May 7, 2001
Project No. 00037-000
File No. P-3

Proposed Revision to Sargent & Lundy (S&L)
Topical Report SL-TR-1A
Quality Assurance (QA) Program

SARGENT & LUNDY LLC
NUCLEAR QUALITY ASSURANCE PROGRAM
TOPICAL REPORT
SL-TR-1A

REVISION 1516

Sargent & Lundy Management Organization Chart
Figure 01.01-1

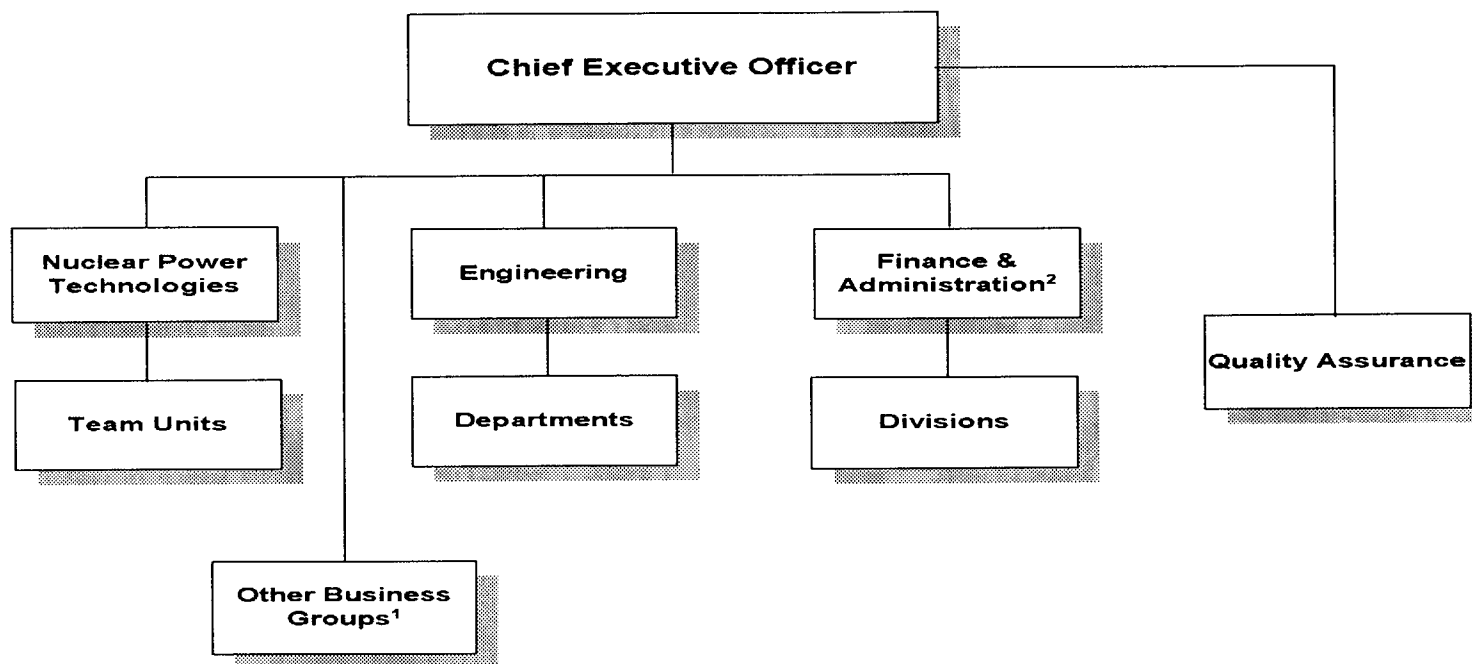
19 S&L's management organizational structure is shown in
20 Figure 01.01-1, Sargent & Lundy Management Organization
21 Chart. Company services are organized into three business
22 groups and two functional support groups. The business
23 groups are Nuclear Power Technologies Diversified
24 ~~Businesses and Management Consulting~~ and other business
25 groups as determined by the Chief Executive Officer. The
26 functional support groups are Engineering and Finance &
27 Administration. ~~Each group is managed by a Director who~~

12 ~~The Director of Diversified Businesses exercises~~
13 ~~administrative control over personnel and management~~
14 ~~resources providing information technology services,~~
15 ~~transmission and distribution services, and operations &~~
16 ~~maintenance services.~~

17 ~~The Director of Management Consulting oversees management~~
18 ~~consulting engagements that provide domestic government and~~
19 ~~industry association services. In a similar fashion, the~~
20 ~~Directors of the other business groups oversee services~~
21 ~~provided within their areas of responsibilities.~~

22 The Director of Engineering exercises administrative
23 control over the Engineering, Technical Support Staff, and
24 Material Management Departments.

3. (Section 01.01) The Engineering, Technical Support Staff, and Material Management Departments of the Engineering Functional Support Group have been replaced by the Project Services and Plant Support Services Departments. The responsibilities of the former three departments have been transferred to the new two departments with the additional responsibilities of OMS.

The Director of Engineering exercises administrative control over the *Project Services and Plant Support Services Engineering, Technical Support Staff, and Material Management* Departments.
